PLAN COMMISSION

July 25, 2017
6:00 P.M.

- b. PLAN REVIEW – Review site, building, landscaping, and lighting plans submitted by Jerry Cousin, All Star Honda, for an automotive sales and service facility on the properties at 7008 and 7018 S. 27th St., and 2500 W. Rawson Ave. (Tax Key Nos. 737-9989-001, 737-9988-001, 737-9037-001). Follow this item on Twitter [@OakCreekPC#OCPCBuickGMC](#).

Sign 2
(1) D/F SIGN
RQ'd

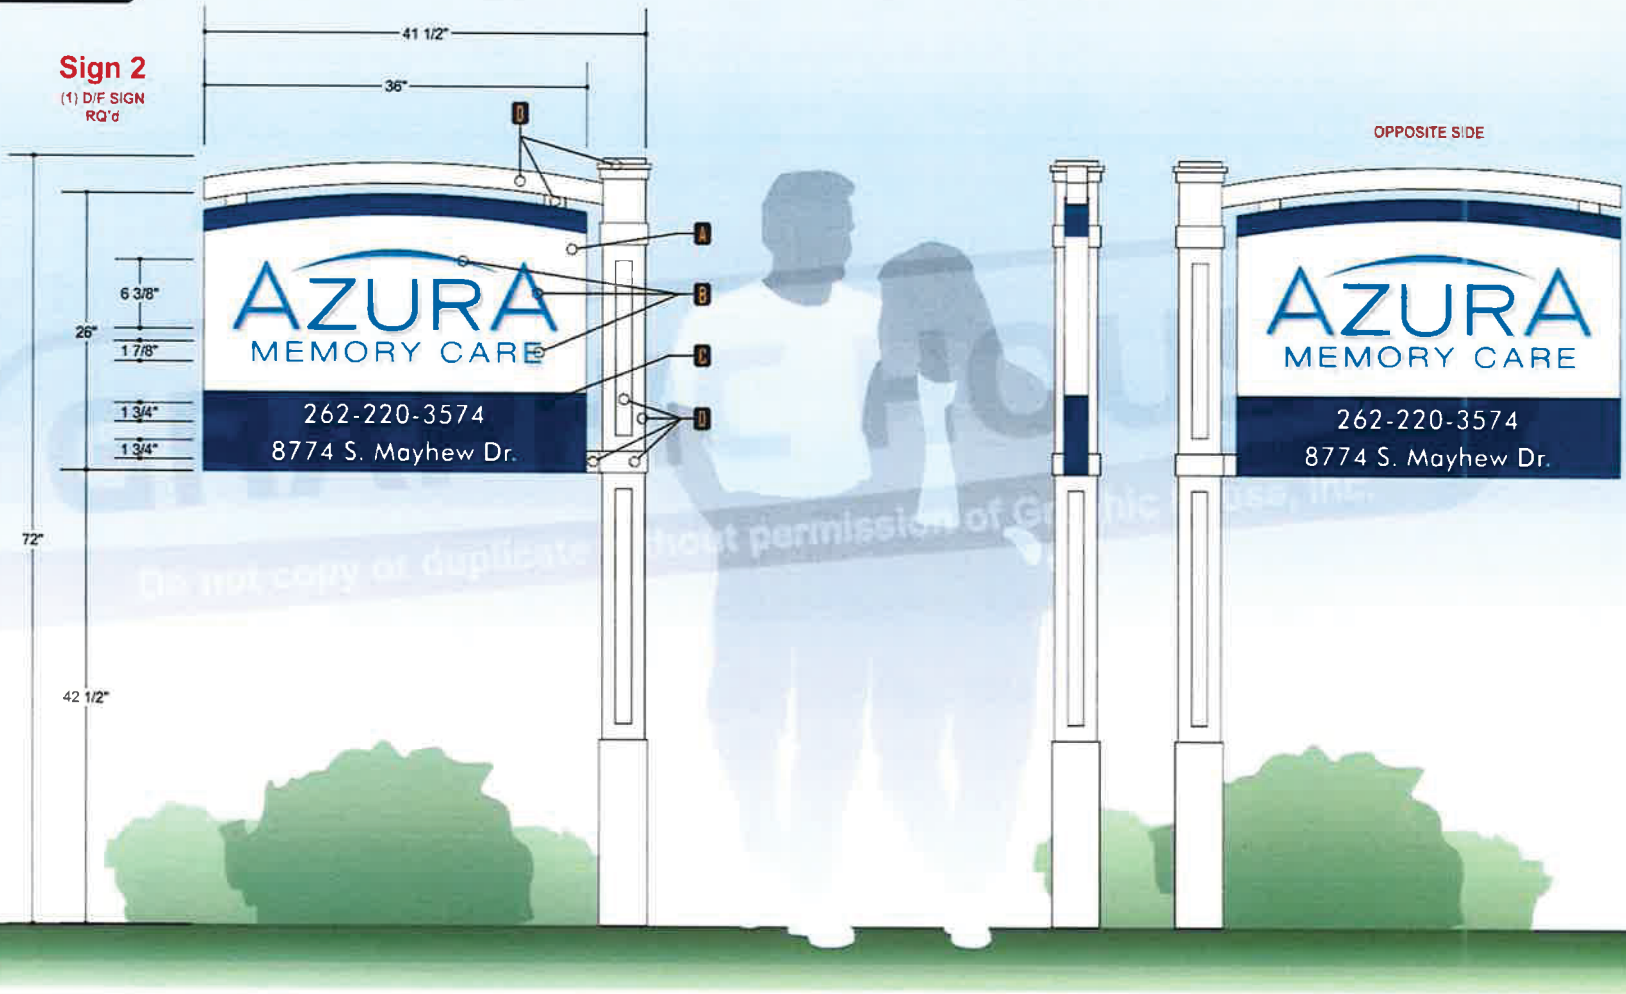
Mayor Bukiewicz stated he does not see the point of having the monument/directional sign #2, which sits on the corner of 6th St. and Drexel Ave. Zoning Administrator/Planner Wagner stated that he is not sure about the granting of the Utility easement and if a variance is going to be allowed. They might not actually be able to put it at that location based on the easement issue or a vision triangle.

Commissioner Dickmann asked if the Plan Commission was saying they do not want the directional sign on Drexel Avenue. Mayor Bukiewicz stated that the right-of-way location is unknown at this time and they may not be able to install the sign in that location anyway. Zoning Administrator/Planner Wagner suggested having the standard highway sign (the blue “H”) to identify where the hospital entrance is instead of having the full directional sign.

If the Plan Commission believes a variance should be granted, a motion can be made to allow for the installation of two residential development signs for the parcel located at 8774 S. Mayhew Drive.

C100

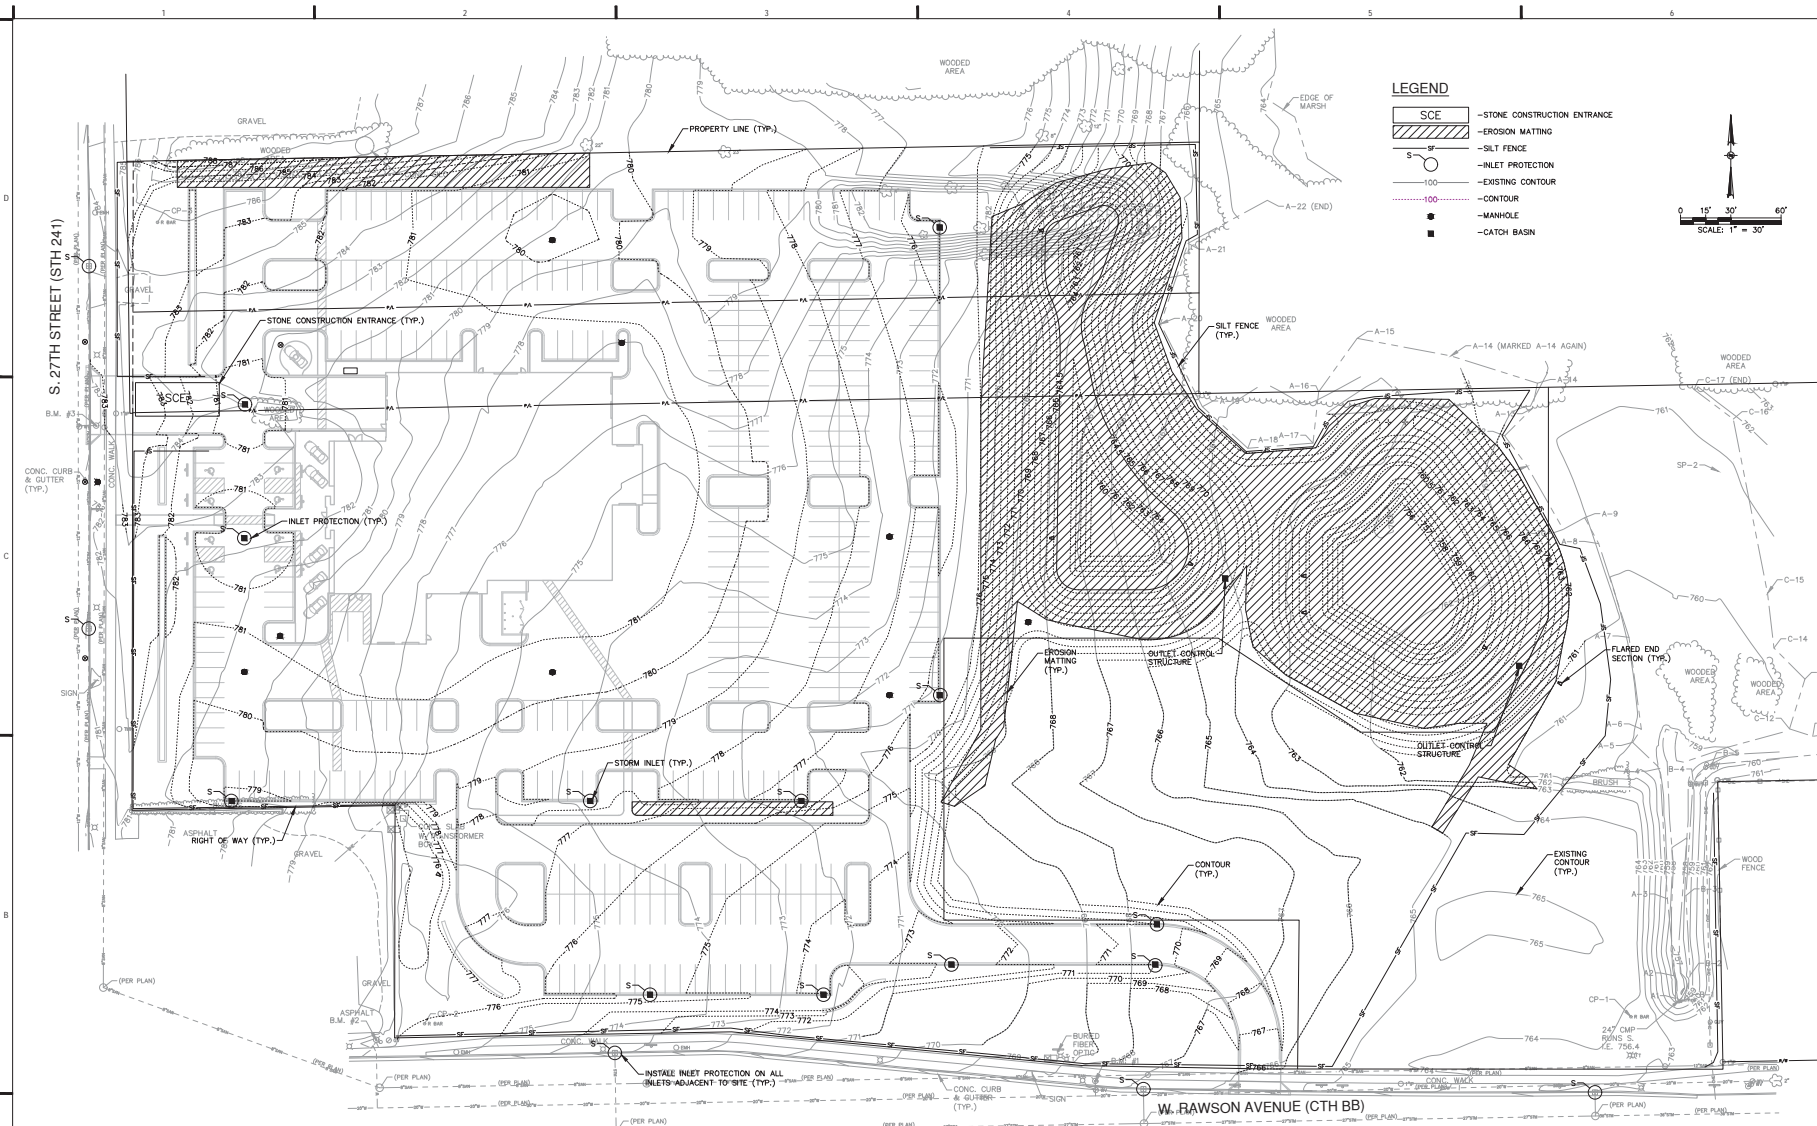
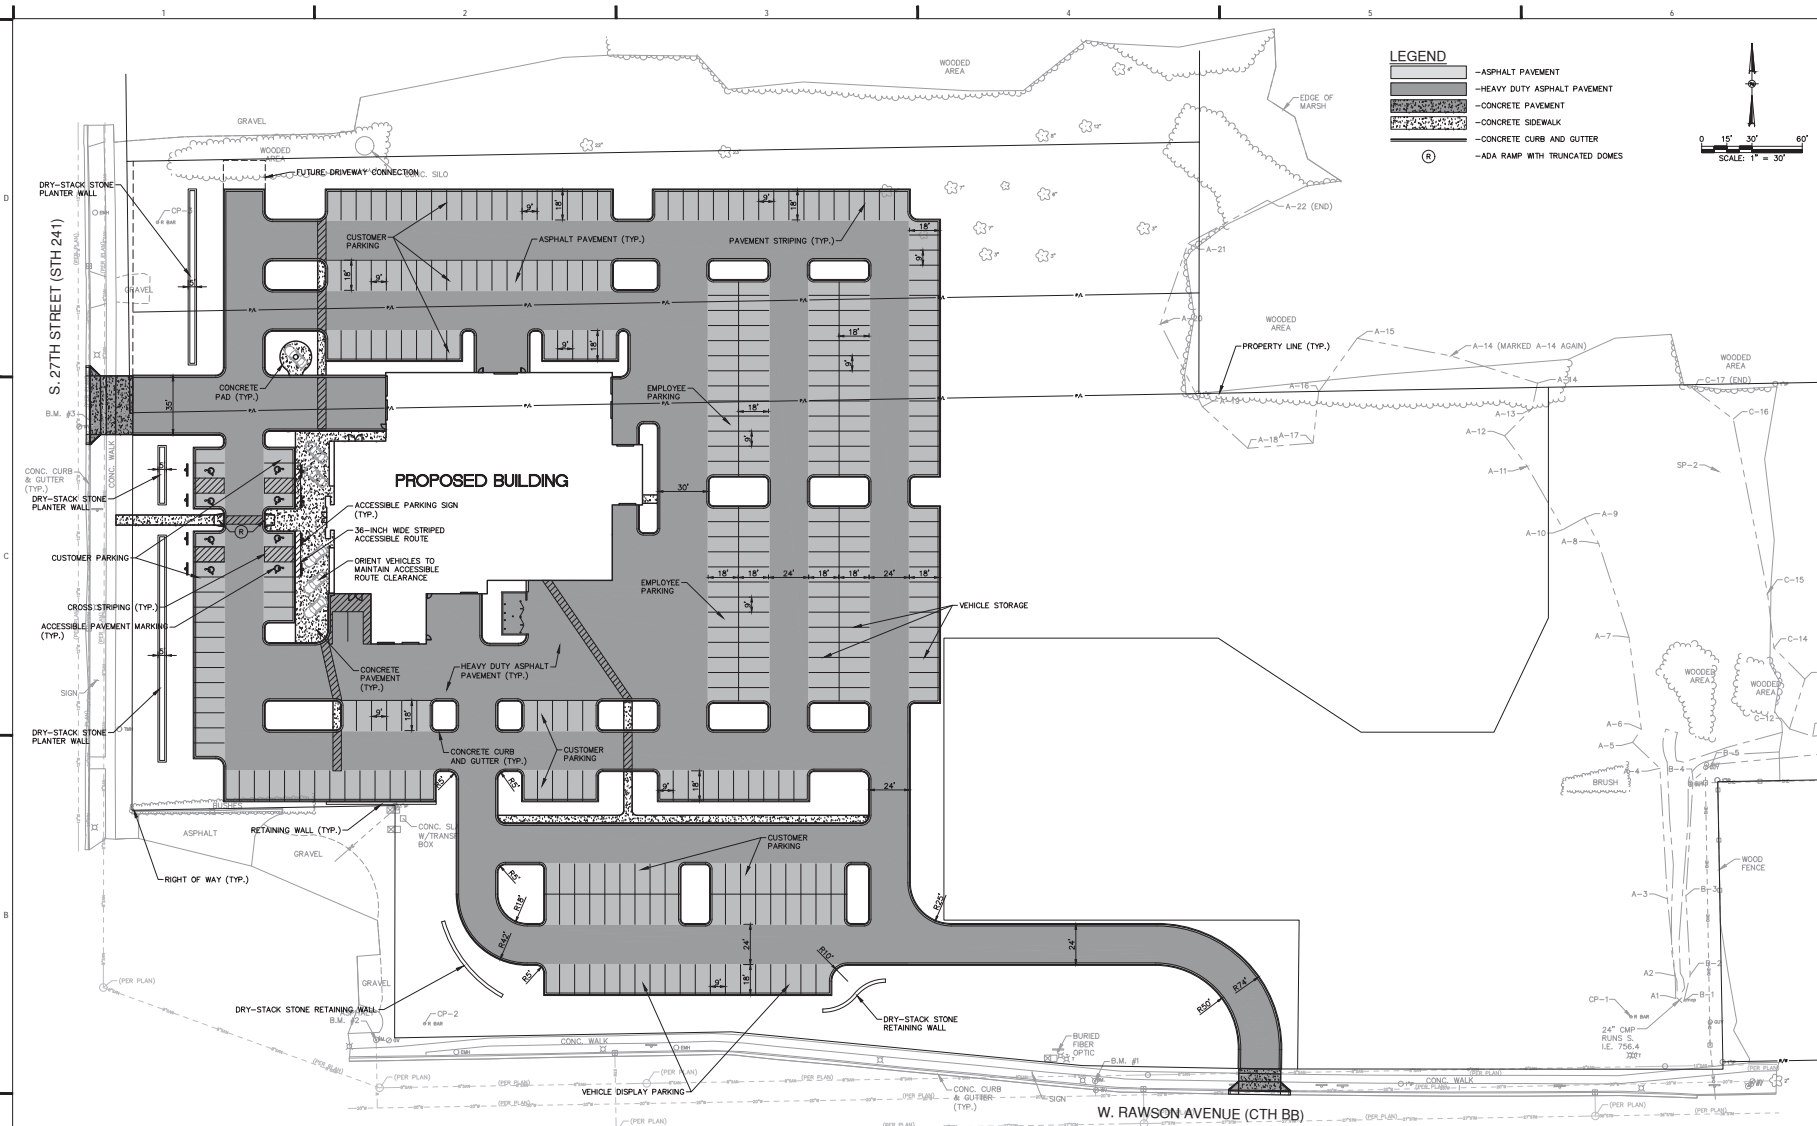
- f. Employee parking identified (52 stalls) separate from customer and merchandise parking (325 overall).
- g. Stormwater pond slightly reconfigured.
- h. Wetlands must be shown on the site plans (missing).

- i. Comments from the Water and Sewer Utility received July 6:
 - i. All utility easements should remain in tact and shown on both the plans and CSM.
 - ii. The developer is proposing that an existing hydrant be removed on 27th St. to accommodate a new entrance. This hydrant and lead must be removed to the main with a cap on the Tee. This will require a water shut down and coordination directly with the Utility no later than 48 hours before the planned shut down.

Comments were also received from the Engineering Department throughout the internal review of the plans. While the plans show a “frontage road” that ties into the proposed public road, Engineering would prefer to see the frontage road completely removed from Rawson Avenue. The Department also reiterates the requirement for WisDOT and Milwaukee County approvals for the access drives (the access permissions previously granted must be modified to allow for the proposed locations in the plans). Wetlands and the stormwater infrastructure locations are also missing on the site plan received May 18.

- Although public sidewalks are provided in the S. 27th Street and Rawson Avenue rights-of-way, there are no direct public connections to those sidewalks provided in the proposal. Further, there are no dedicated pedestrian paths separate but adjacent to the vehicle display area along Rawson Avenue. Staff contends that there are viable options to provide better vehicular and pedestrian-friendly connections throughout the site.

1 SOUTH ELEVATION
SCALE: 1/8" = 1'-0"

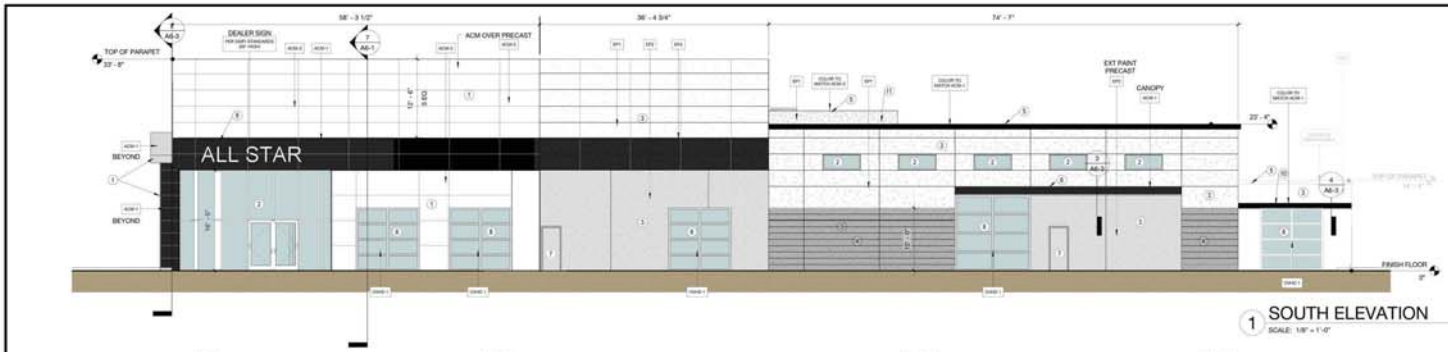
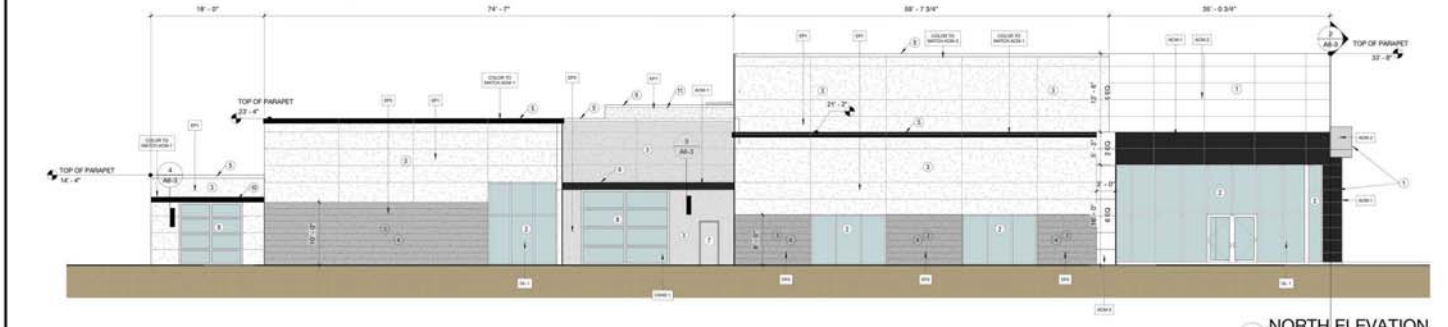
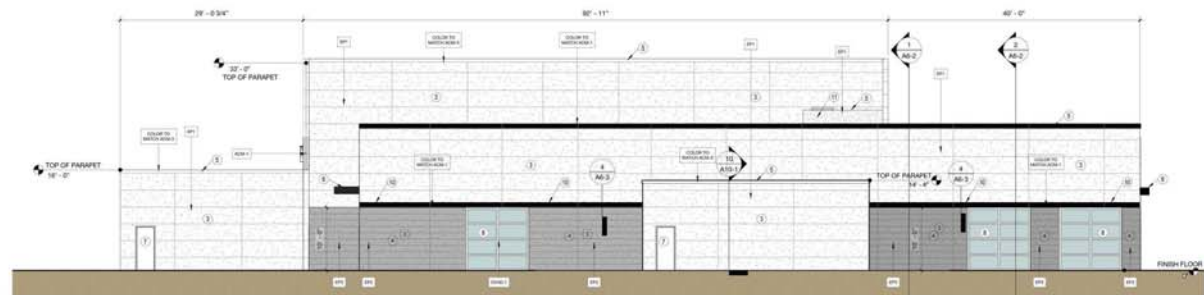
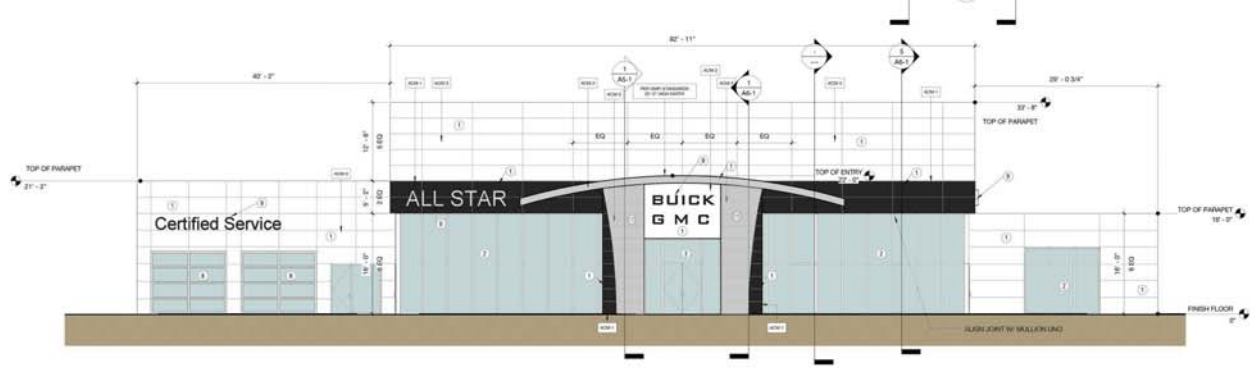
- As mentioned in the review of the plans per the Standard Sections of Chapter 17 above, all but one of the overhead doors incorporate glass panes to mimic windows. This was a suggested

- Metal panels are becoming more frequently proposed in plans received for review by the City. Although not specifically discussed during the building material training at the April 25 meeting, information was provided regarding their durability, aesthetics, etc. Staff has noted in reviews of other GMC dealerships throughout the country that use metal panels that some of the panels clearly show rusting and deterioration. Information regarding the quality and durability of the proposed panels must be provided to staff and the Plan Commission.

- As previously mentioned, the building does not use any of the materials required in this Section of Code, and the proposed materials do not meet the express requirements of other Sections of Code. Plan Commissioners will recall that a text amendment was recently passed by Council that would allow for a modification of standards as described below:

- Staff notes that the west (front) façade features are only extended for approximately 30’ 8 ¼” on the north and south façades. It will be up to the Plan Commission to determine whether this Section of Code is satisfied by the proposed elevations.

- a. Option 2 was chosen, showing a contrasting color for portions of the precast concrete on the north and south elevations.
- b. Black metal caps were also added as accents to some of the parapets/rooflines on the north and south elevations.
- c. Materials samples have been provided per Plan Commission request.
